Access Compliance Report

Public Rights-of-Way

(Curb Ramps)

Intersection ID: 16805	Main Street: N_SHARON_AMITY_RD	Cross Street: KELLY_ST	Location: NW
ADA ID: 04F017F618CB	Ramp Type: PerpDiag	Initial Pass/Fail: Fail	Overall Compliance: No
Severity Score: 42.5			
Codes/Mitigation Info/Possible Solution		Field Measurements/Component Compliance

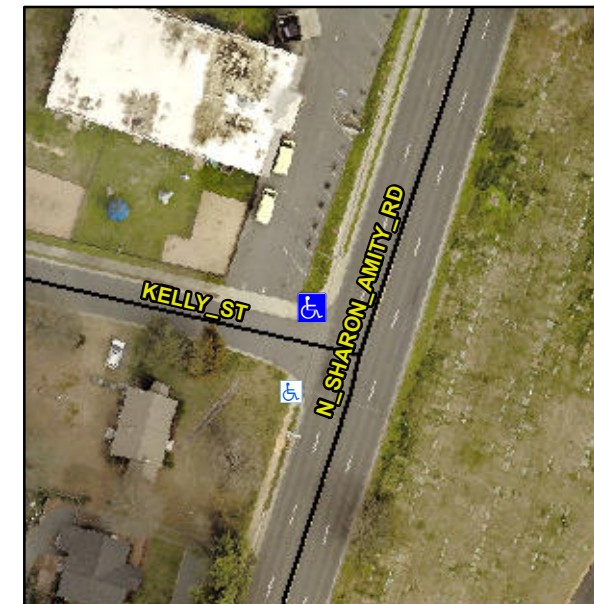
PROW/ADA:

R304.5.1, R304.5.3

Compliance	Description	Data	Compliance	Description	Data
N/A	Ramp Length (in)	75.0	Yes	Ramp Slope (%)	5.2
No	Ramp Width (in)	33.0	No	Ramp XSlope (%)	15.8
N/A	Flare Type LT	N/A	N/A	Flare Type RT	N/A
N/A	Flare Slope LT (%)	N/A	N/A	Flare Slope RT (%)	N/A
N/A	Flare Traversable LT?	N/A	N/A	Flare Traversable RT?	N/A
N/A	Landing Length (in)	N/A	N/A	DWS Provided?	N/A
N/A	Landing Width (in)	N/A	N/A	DWS Contrast?	N/A
N/A	Landing Slope (%)	N/A	N/A	DWS Length (in)	N/A
N/A	Landing X Slope (%)	N/A	N/A	DWS Full Width?	N/A
N/A	Landing Curb? (Y/N)	N/A	N/A	DWS Offset (in)	N/A
N/A	Shared Landing?	N/A			
N/A	Gutter Ponding?	N/A	N/A	Gutter Slope (%)	N/A
N/A	Gutter Lip Ht (in)	N/A	N/A	Gutter X Slope (%)	N/A
N/A	Painted X Walk1?	No	N/A	Painted X Walk2?	No
	X Walk 1 Direction	To SW		X Walk 2 Direction	To SE
N/A	X Walk 1 Width (in)	N/A	N/A	X Walk 2 Width (in)	N/A
	X Walk 1 Slope (%)	4.4		X Walk 2 Slope (%)	13.9
	X Walk 1 X Slope (%)	14.2		X Walk 2 X Slope (%)	0.4

N/A	Ramp inside XWalk1?	N/A	N/A	Ramp inside XWalk2?	N/A
	Road Slope (%)	10.7	N/A	Clear Space?	N/A
	Road X Slope (%)	12.1	N/A	Clear Space to XWalk (in)	N/A
N/A	Any Obstructions?	N/A	N/A	Storm Grate/Utility Hazard?	N/A
	Obstruction Type			Storm Grate/Utility Type	
		N/A			N/A
			Yes	Surface Condition? (G/P)	Good

Remove & Replace Curb Ramp With Two New Directional Ramps or Equivalent.
